UNITED STATES
DEPARTMENT OF THE INTERIOR
BUREAU OF LAND MANAGEMENT
Sundry Notices and Reports on Wells

8. Well Name & Number
Navajo #1

13. Describe Proposed or Completed Operations

Proposed P&A

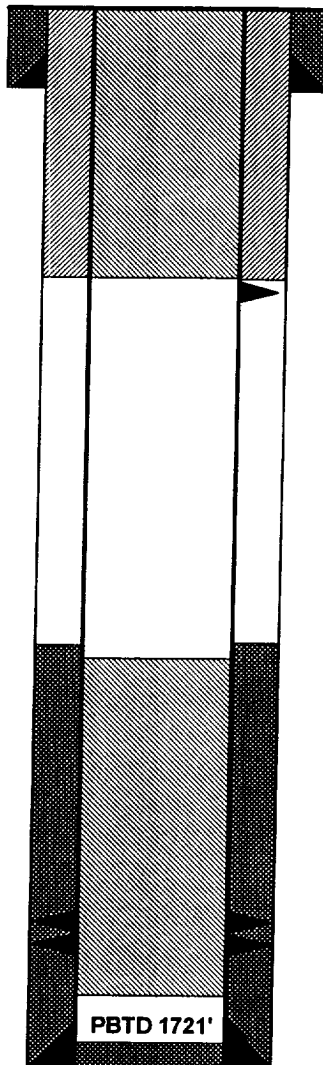
Texas Pacific Oil and Gas Co., proposes to revise the February 24, 1997, approved Plug and Abandon procedure for this well per the attached procedure and diagram.

The procedure change to a pump down type is necessary because the old pad for this well is quite small and is located on a sandstone bench which is surrounded by very rough terrain. An extensive amount of dirt work would be necessary before a rig would fit.

Plug #2 305' - Surface
Cmt with 55 sxs Class B.

Perforate at 305'

Plug #1 1704' - 1265'
Cement with 63 sxs Class B
(50% excess, long plug)

1. RIH with wireline and tag bottom. Install cementing head. Pump 20 bbls water ahead. Plug #1 from 1704' to 1265' with 63 sxs Class B cement. Shut in and WOC.
2. WOC, tag cement with wireline; then pressure test casing to 500#.
3. Perforate 2 squeeze holes at 305'. Establish circulation out bradenhead. Mix and pump approximately 55 sxs Class B cement from 305' to surface, circulate good cement out bradenhead.
4. WOC, cut off wellhead and install P&A marker.
